MEMORANDUM

To: Cambridge Planning Board
From: Susan E. Clippinger, Director
Date: October 3, 2014
Re: The Residences at #88 Cambridgepark Drive (Formerly 180R Cambridgepark Drive)

Re: 88 Cambridgepark Drive
Proposed Project Program Revisions

To: Cambridge Planning Board
From: Susan E. Clippinger, Director 
Date: July 8, 2014
Re: The Residences at 180R Cambridgepark Drive

Cumulative Development Trips
(Projected Increase over Existing)

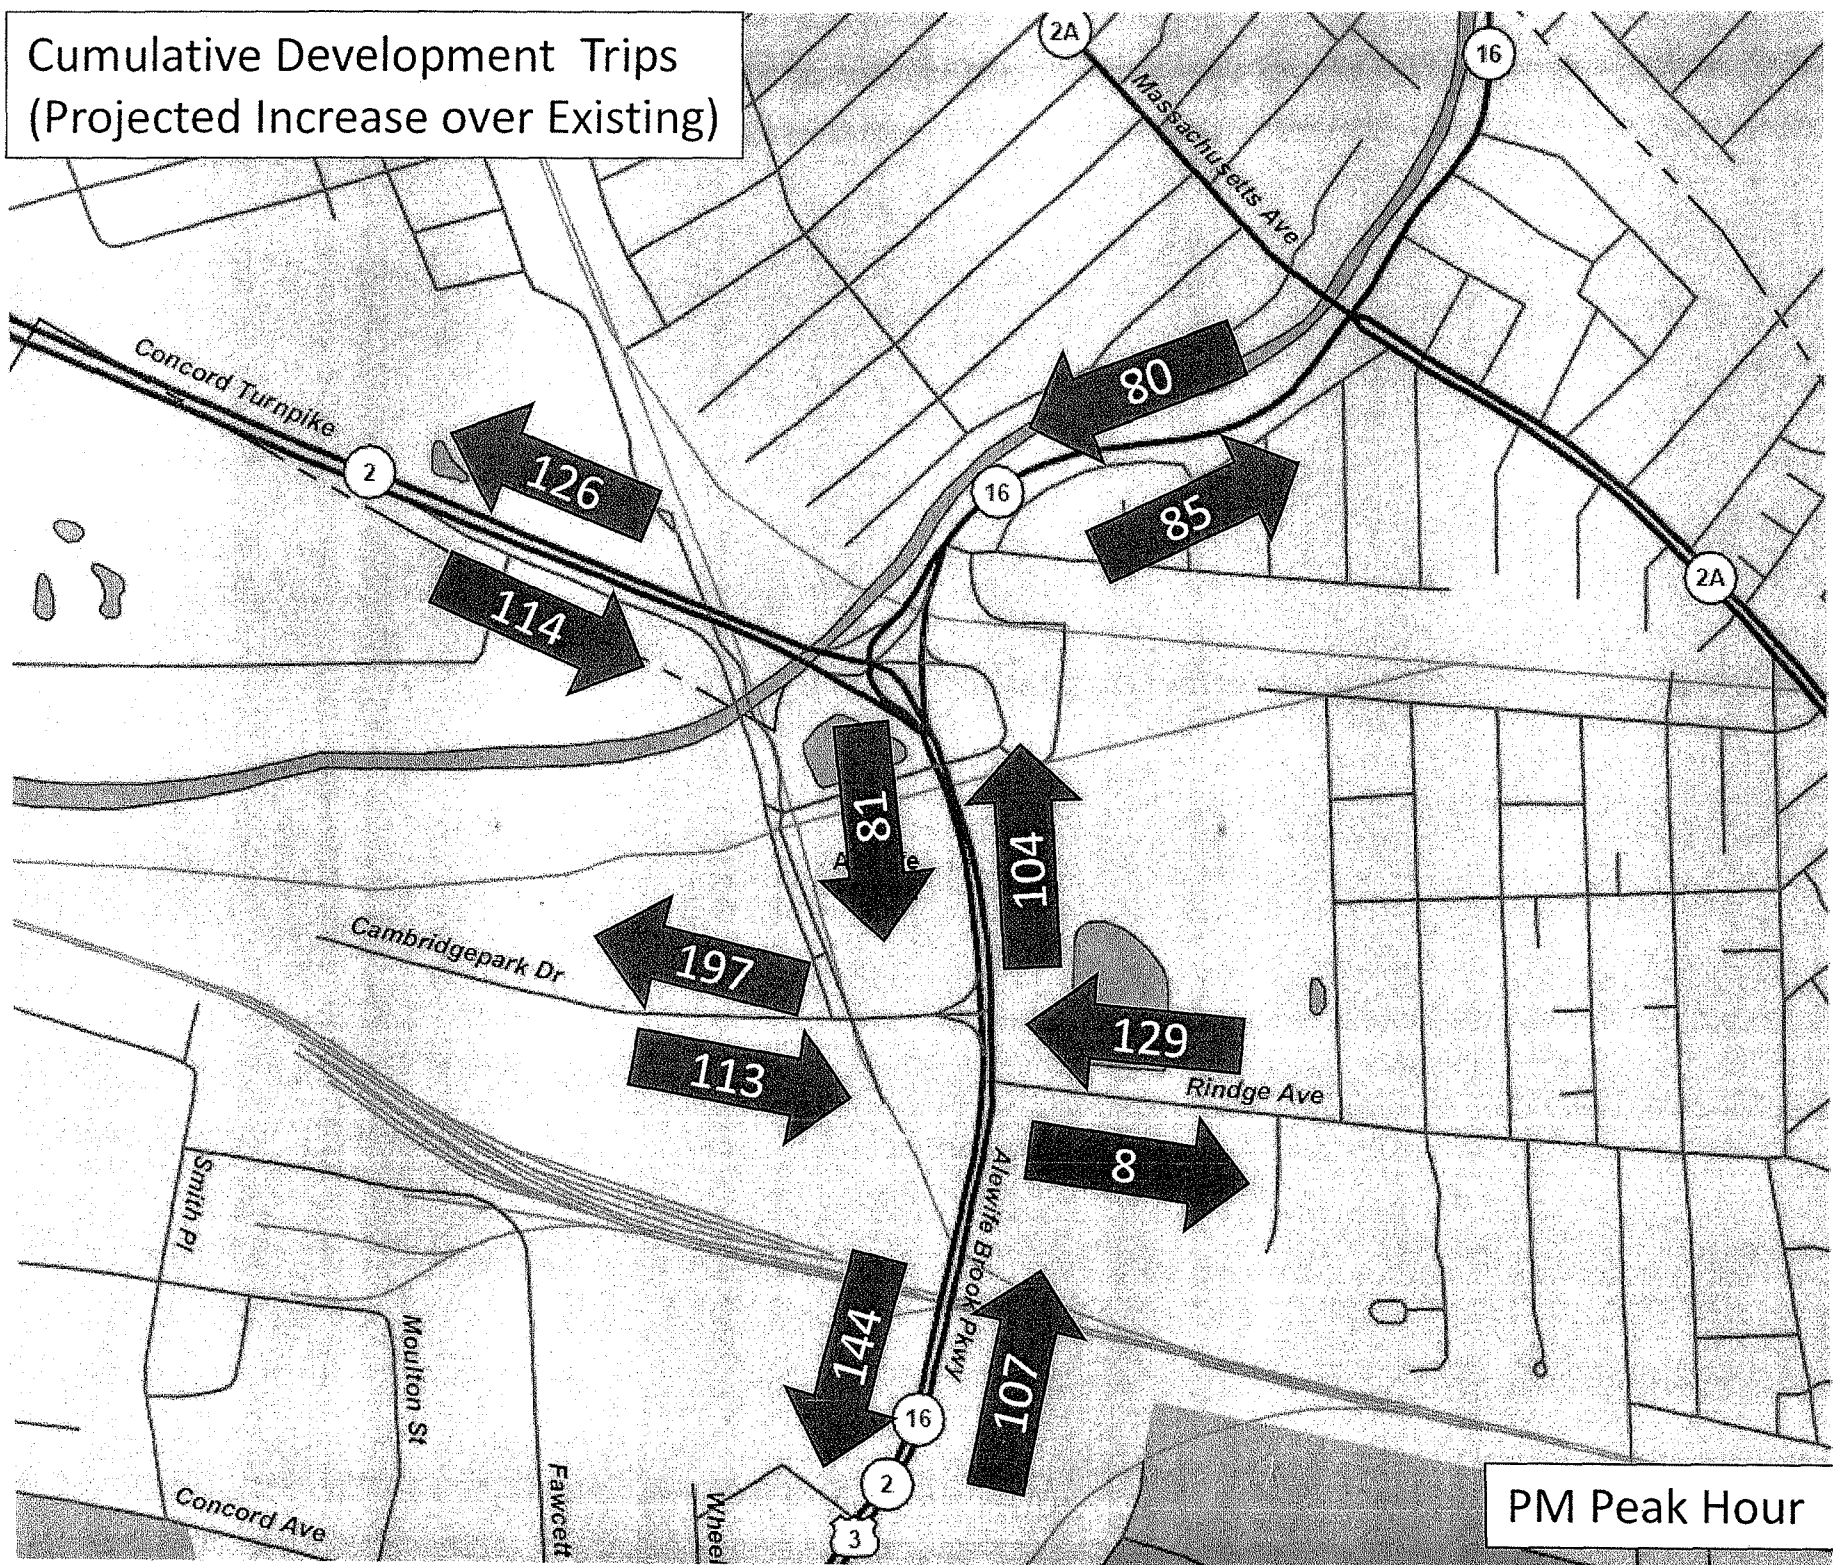
- D. Provide an updated graphic for the cumulative AM and PM peak hour traffic, similar to the graphic attached.**

Updated graphics depicting the cumulative AM and PM peak hour development trips in the study are attached.
